# Access Compliance Report

## Public Rights-of-Way

### (Curb Ramps)

Intersection ID: 9810	Main Street: BRIDGEPORT_DR	Cross Street: THE_PLAZA	Location: NE
ADA ID: 69240875B4B0	Ramp Type: Perp	Initial Pass/Fail: Fail	Overall Compliance: No
Codes/Mitigation Info/Possible Solution		Field Measurements/Component Compliance	
Severity Score: 21.25

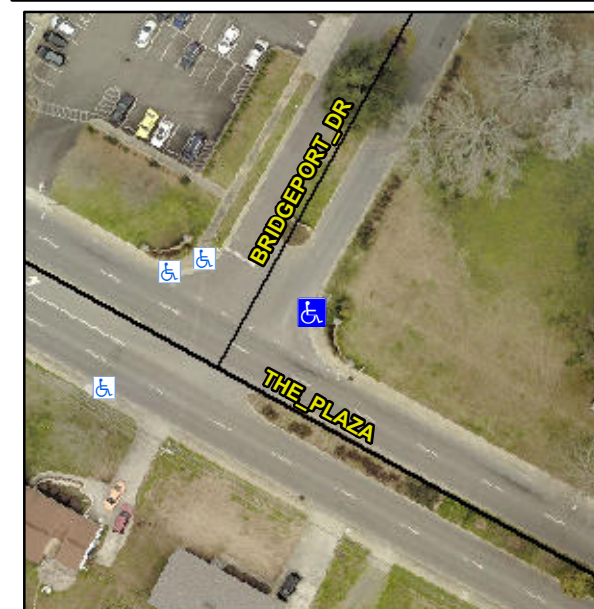
**R304.5.1, R304.2.2**

Compliance	Description	Data	Compliance	Description	Data
N/A	Ramp Length (in)	57.0	No	Ramp Slope (%)	11.0
No	Ramp Width (in)	47.5	Yes	Ramp XSlope (%)	1.3
N/A	Flare Type LT	N/A	N/A	Flare Type RT	N/A
N/A	Flare Slope LT (%)	N/A	N/A	Flare Slope RT (%)	N/A
N/A	Flare Traversable LT?	N/A	N/A	Flare Traversable RT?	N/A
N/A	Landing Length (in)	N/A	N/A	DWS Provided?	N/A
N/A	Landing Width (in)	N/A	N/A	DWS Contrast?	N/A
N/A	Landing Slope (%)	N/A	N/A	DWS Length (in)	N/A
N/A	Landing X Slope (%)	N/A	N/A	DWS Full Width?	N/A
N/A	Landing Curb? (Y/N)	N/A	N/A	DWS Offset (in)	N/A
N/A	Shared Landing?	N/A			
N/A	Gutter Ponding?	Yes	N/A	Gutter Slope (%)	N/A
N/A	Gutter Lip Ht (in)	N/A	N/A	Gutter X Slope (%)	N/A
N/A	Painted X Walk1?	No	N/A	Painted X Walk2?	N/A
	X Walk 1 Direction	To NW		X Walk 2 Direction	N/A
N/A	X Walk 1 Width (in)	N/A	N/A	X Walk 2 Width (in)	N/A
	X Walk 1 Slope (%)	0.4		X Walk 2 Slope (%)	N/A
	X Walk 1 X Slope (%)	2.1		X Walk 2 X Slope (%)	N/A

**Remove & Replace Entire Ramp.**
